**CITY OF WINTER GARDEN
WESTERN STORAGE, PUMPING & TRANSMISSION FACILITIES**

Addendum No. 2

May 1, 2018

7 EXTERIOR BLDG SLAB
SCALE: 1/2" = 1'-0"

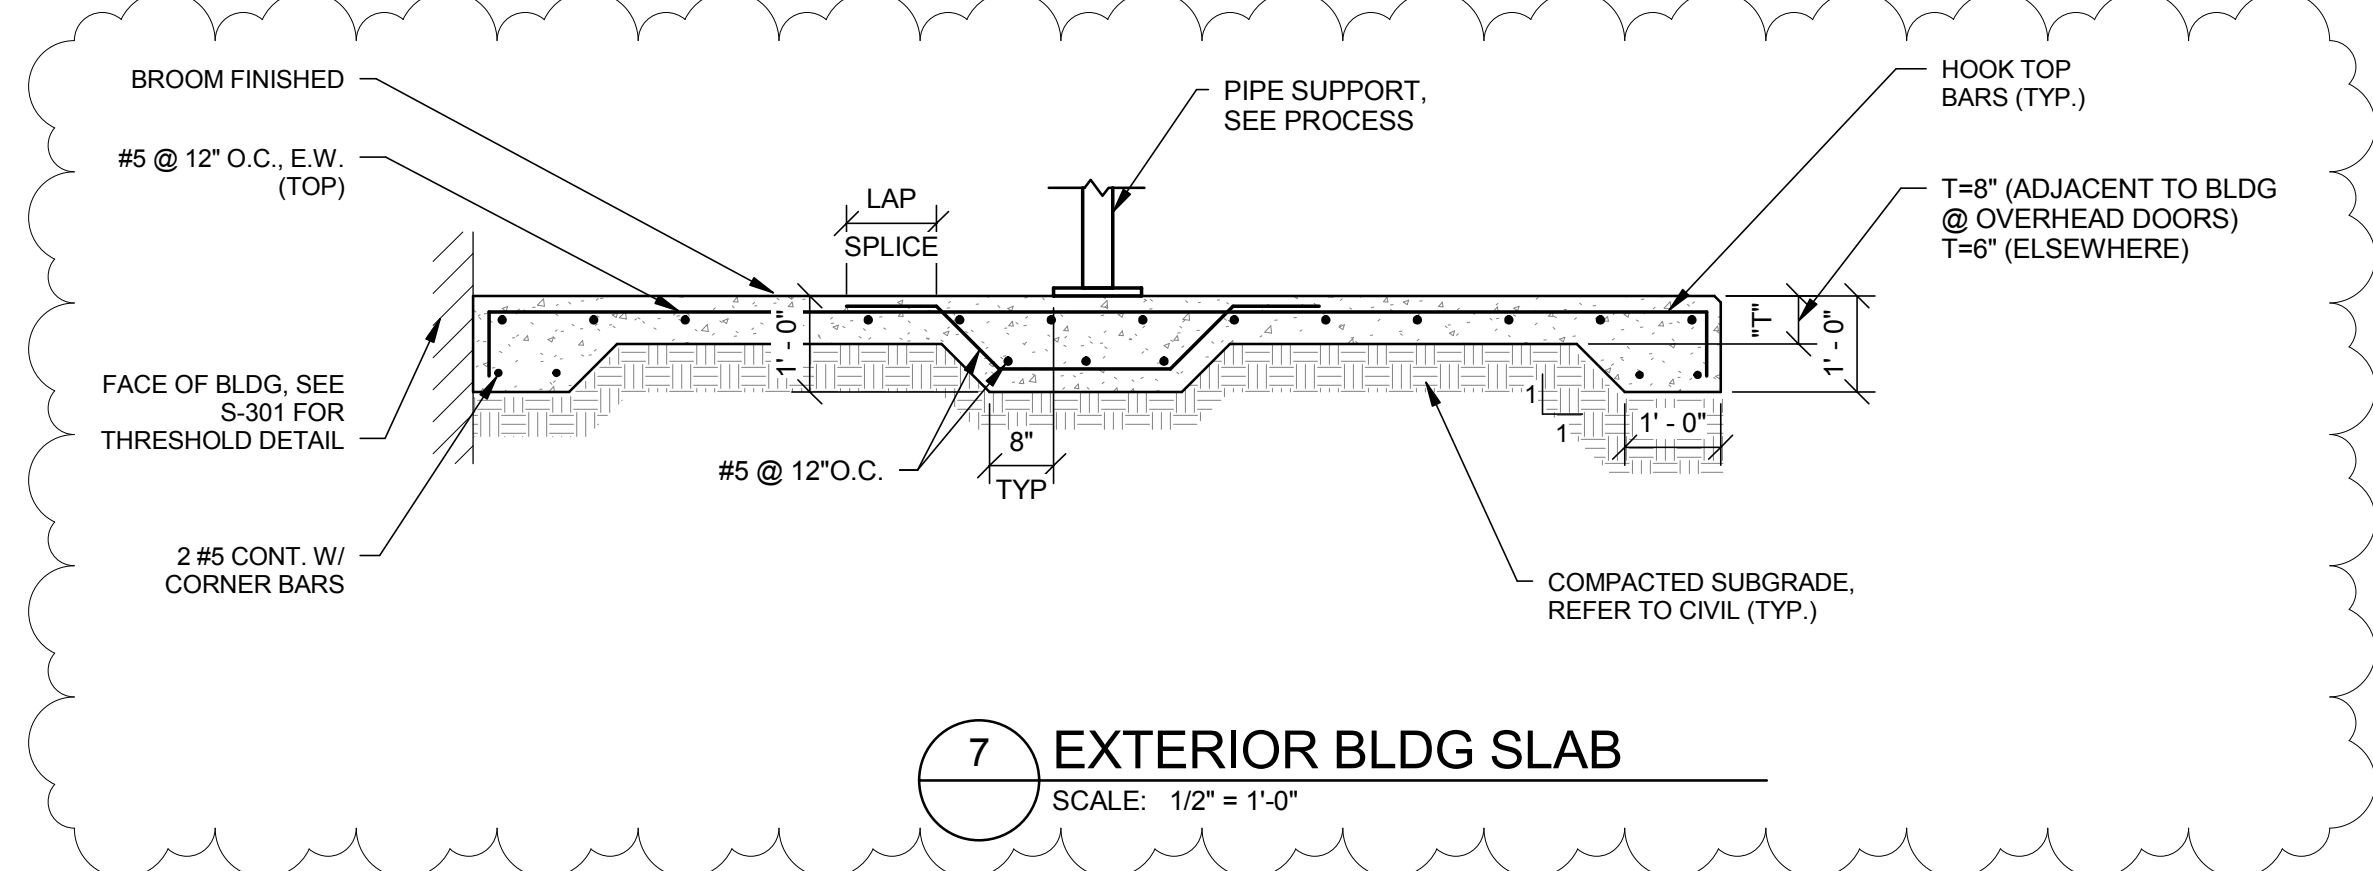
Question 34: Please confirm that the concrete slab outside of the High Service Pump Building is 6" thick. Also, refer to Dwg. S-301, detail C Threshold Section. What is the proposed reinforcing detail and dowel spacing of the concrete slab adjacent to the building slab?

Answer 34: Drawing Sheet S-501 has been revised and reissued by this Addendum No. 2 to provide additional information on the exterior concrete slabs.

- A. Drawing Sheet S-501 – Structural Typical Details. DELETE Sheet S-501 in its entirety and REPLACE with attached Sheet S-501.
- B. Drawing Sheet E-504/Detail 28. DELETE all four (4) references to “SITESECURE”. DELETE the “AIPHONE IS-IPDVF VIDEO INTERCOM STATION”.
